**PLAN COMMISSION
MEETING NOTICE AND AGENDA
Thursday, September 17, 2020
7:00 PM**

REPORT TO THE PLAN COMMISSION

Briohn Building, on behalf of the applicant Laurie Stollenwerk, submitted a Certified Survey Map and Site & Building Plans for a proposed multi-tenant industrial speculative building for property located at approximately N17W25045 Bluemound Road (Tax Key Nos. 0948985003 and 0945989001).

Discussion and Action Regarding the Site and Building Plans for a Proposed 218,000 Square Foot Multi-Tenant Building for the Pewaukee 16-94 South Industrial Development Located at N17 W25045 Bluemound Road (PWC 0948985003 & PWC 0945989001)

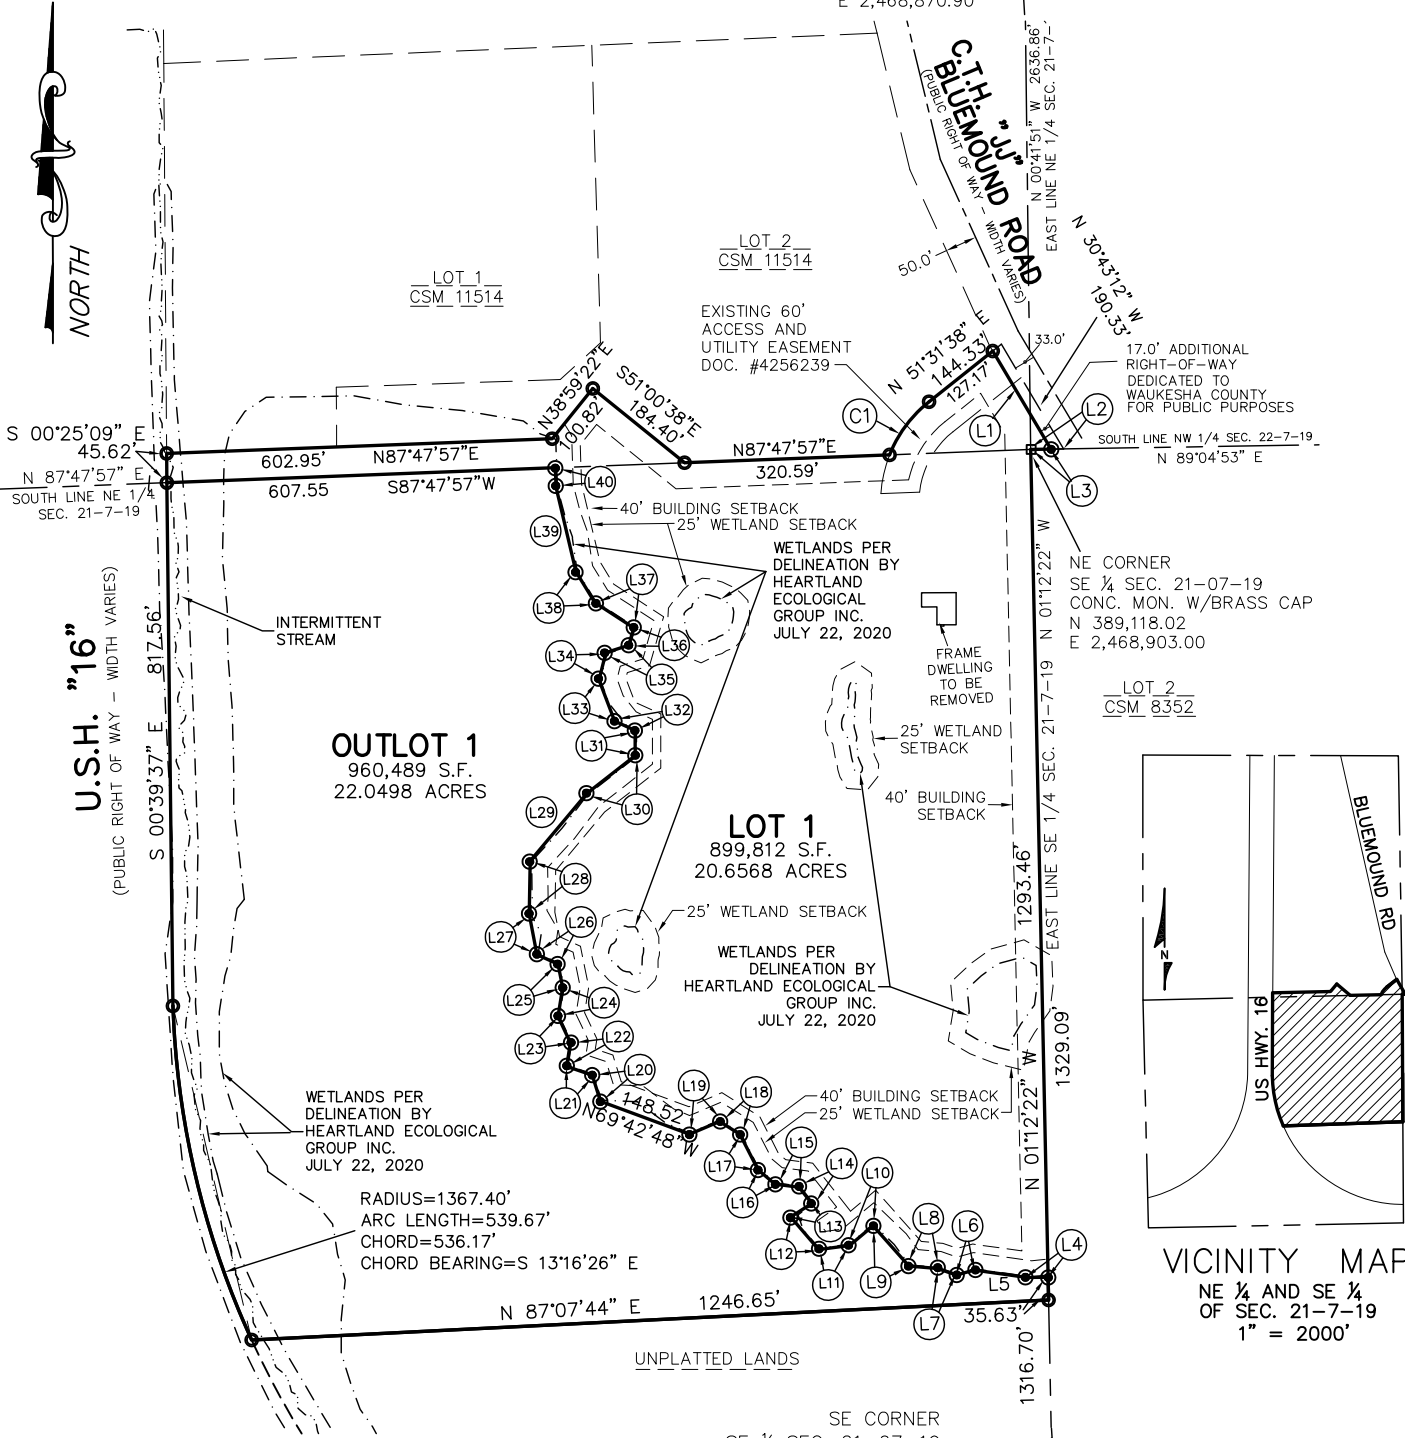
A motion to approve the Certified Survey Map reconfiguring properties located at approximately N17W25045 Bluemound Road (Tax Key Nos. 0948985003 and 0945989001), subject to showing the former property line on Sheet 1.

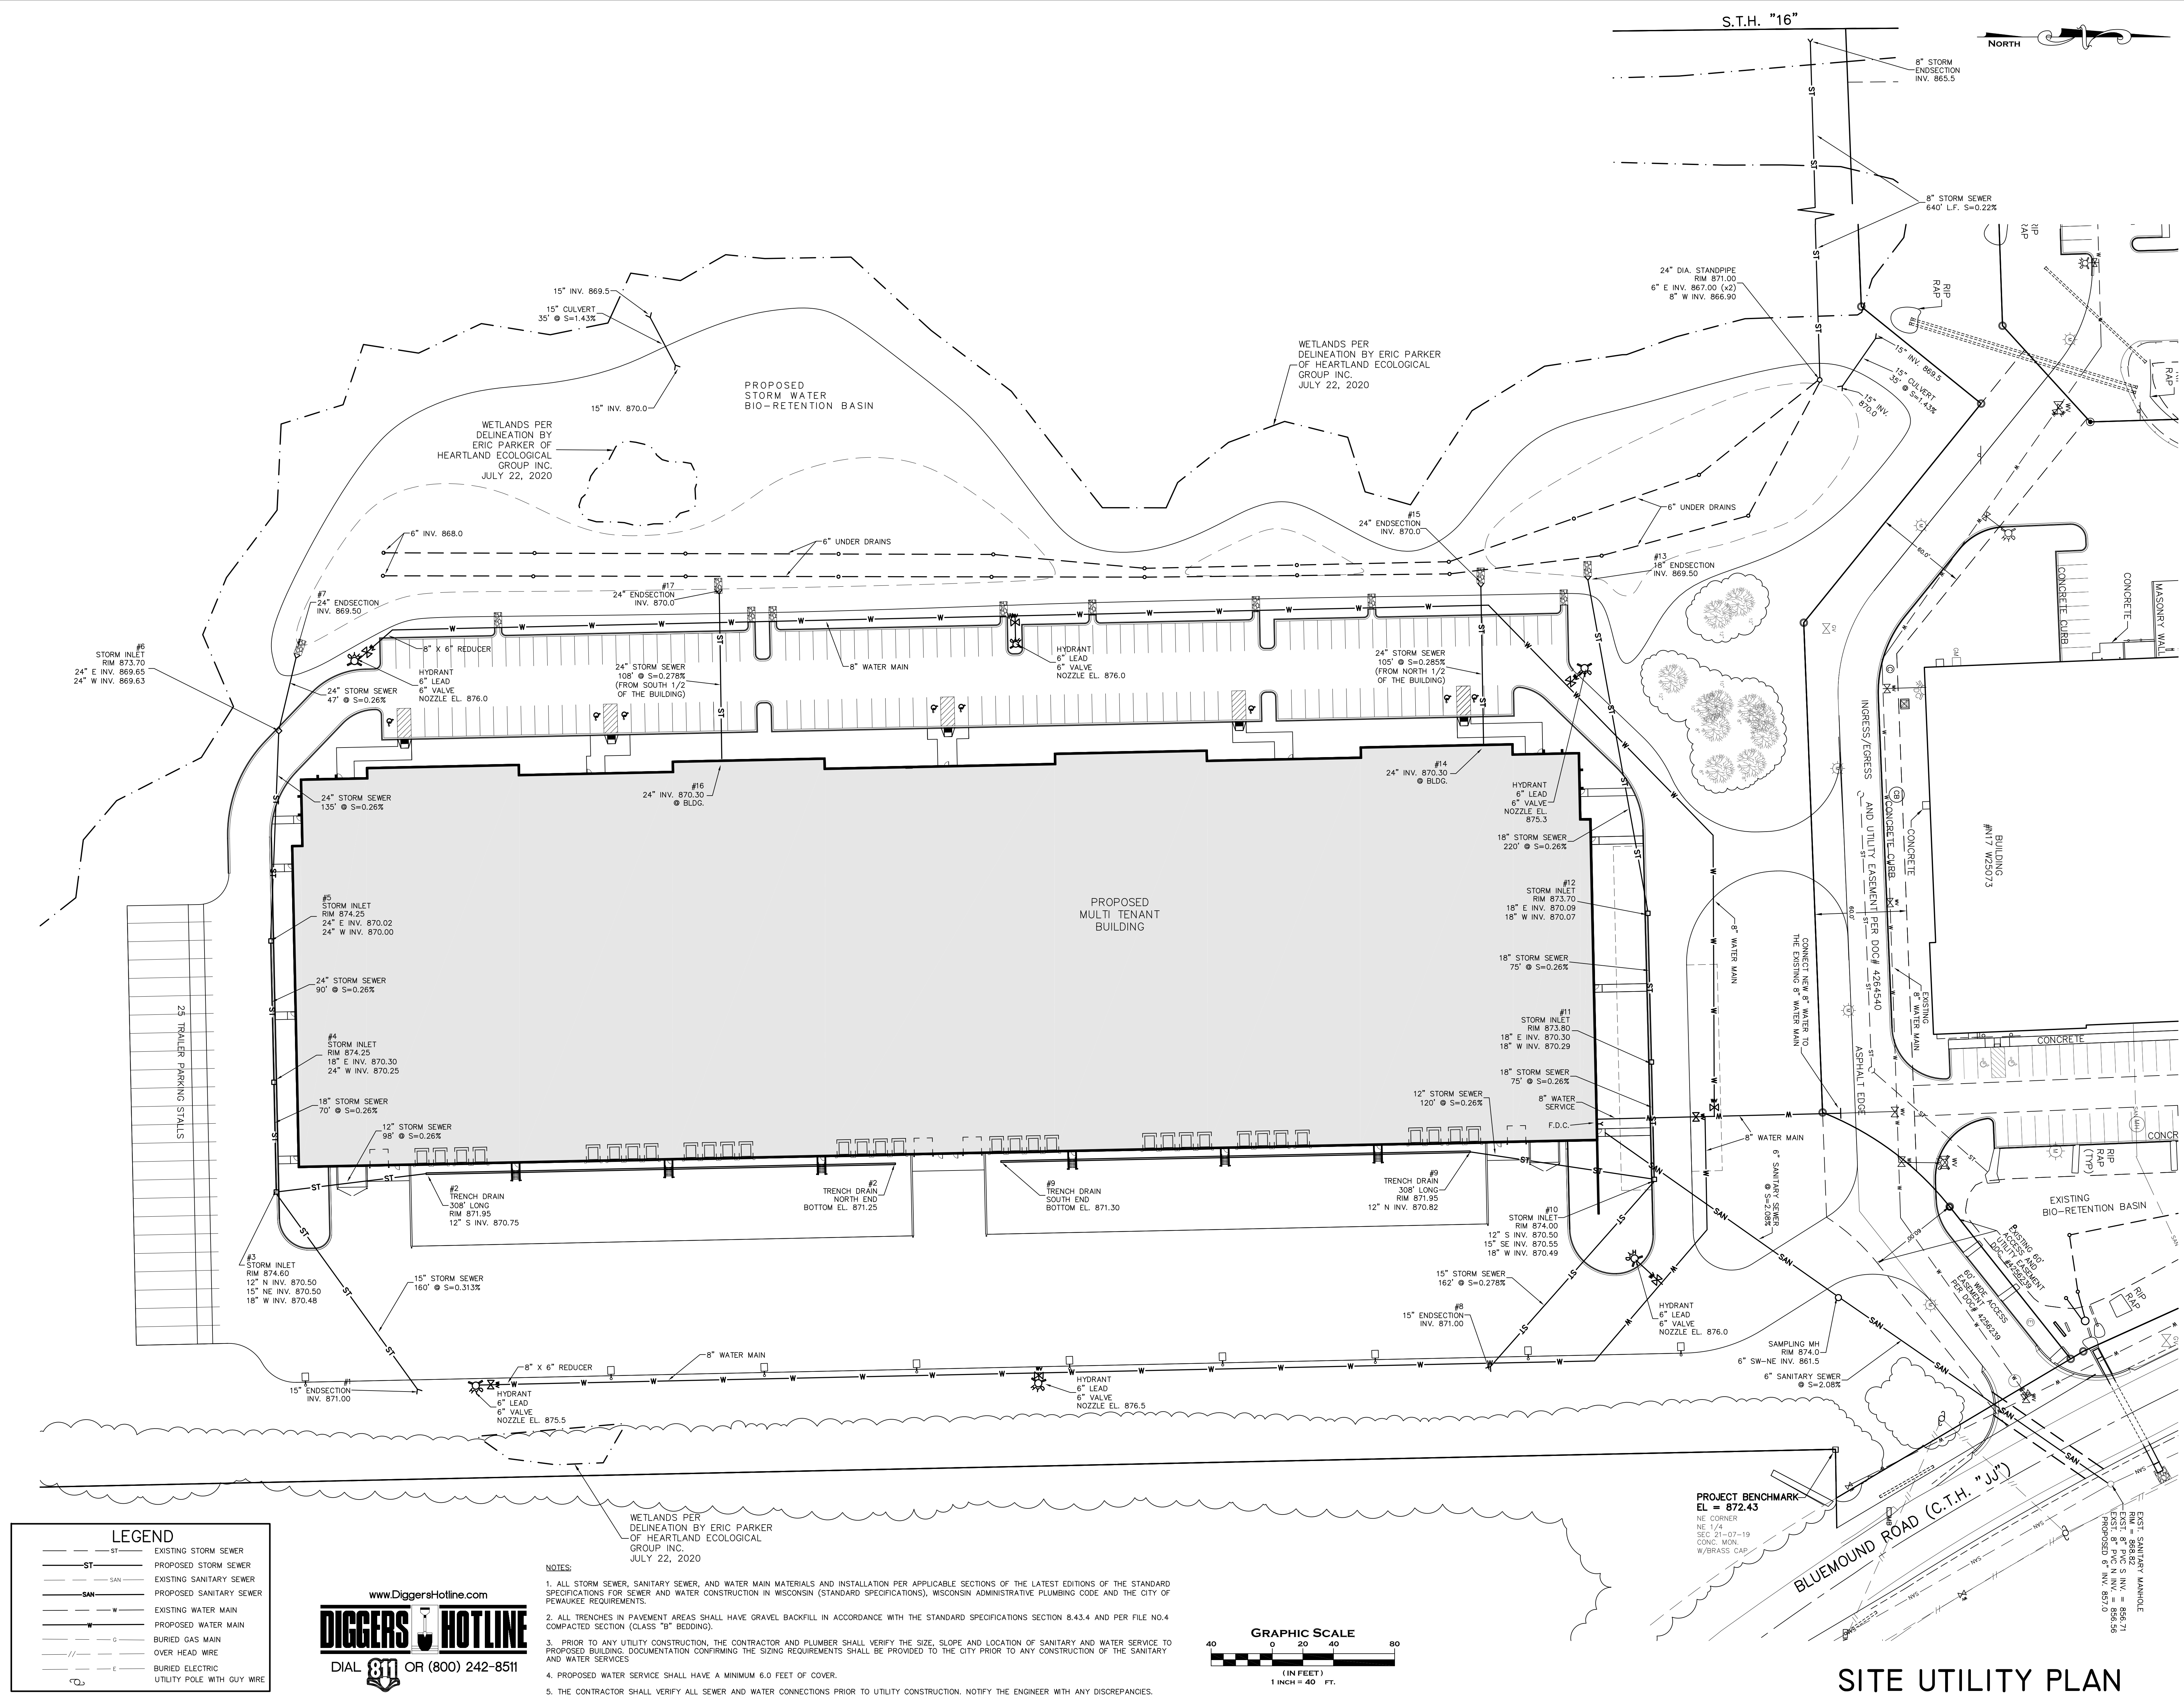
Related to the site plan, staff recommends:

- *Final grading, erosion control and storm water management plans shall be submitted for approval by the Engineering Department prior to any land disturbance.*
- *No outdoor storage shall be allowed other than trailers parked within the designated trailer parking area to the south of the building.*

TREE INVENTORY PLAN
Scale: 1" = 50'0"

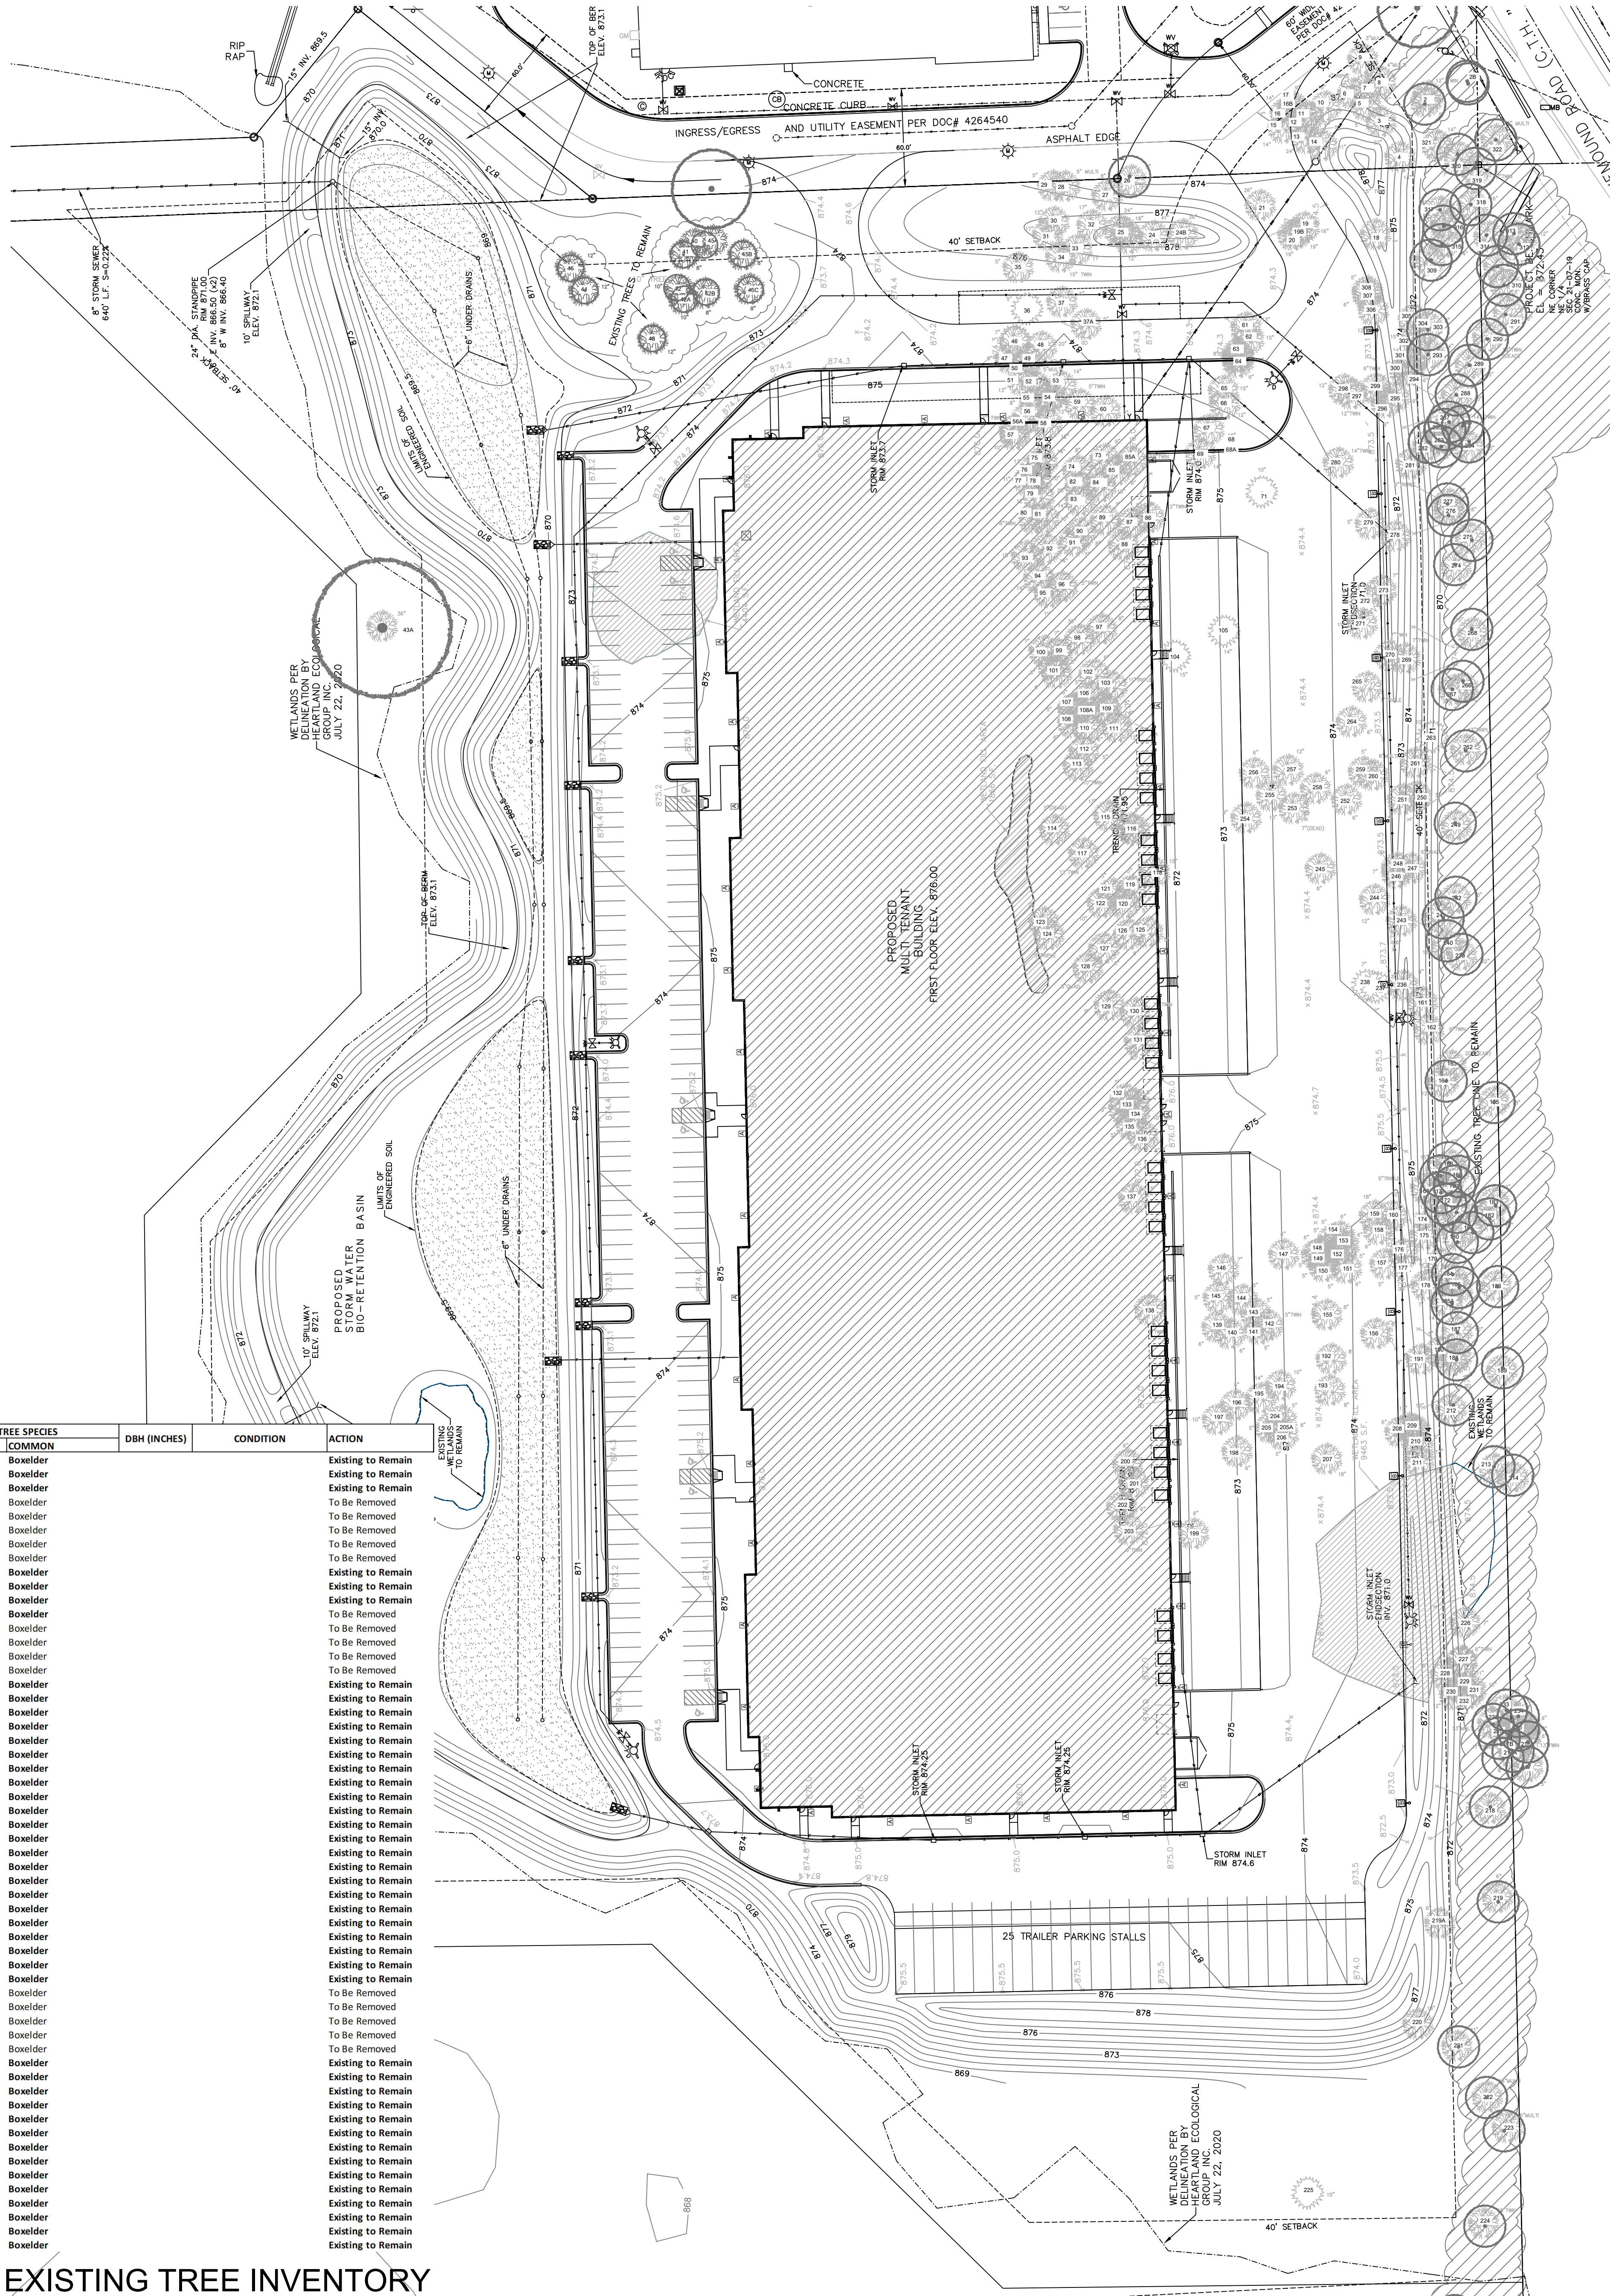
Removal of existing trees will occur throughout the site. According to the tree inventory plan, which includes trees with a dBH of 4-inches or greater, about 335 trees will be removed and 95 preserved. Trees onsite primarily consist of Boxelders.

As tree removal is significant, staff is recommending that following tree removal and installation of landscaping onsite, the applicant and City staff shall review perimeter landscaping and tree lines, particularly along the east side of the property, to ensure that screening is sufficient. If the new and remaining plantings do not provide appropriate screening as determined by staff or the Plan Commission, the applicant shall provide infill plantings, as reasonably practicable at the direction of staff or the Plan Commission, to further mitigate for the tree impacts onsite. Mitigation shall only be required for trees of a 6" caliper or greater and shall not exceed a 1:1 ratio (one tree required for every one tree removed). The review of landscaping and screening shall not result in a shift to the building or parking lot locations.
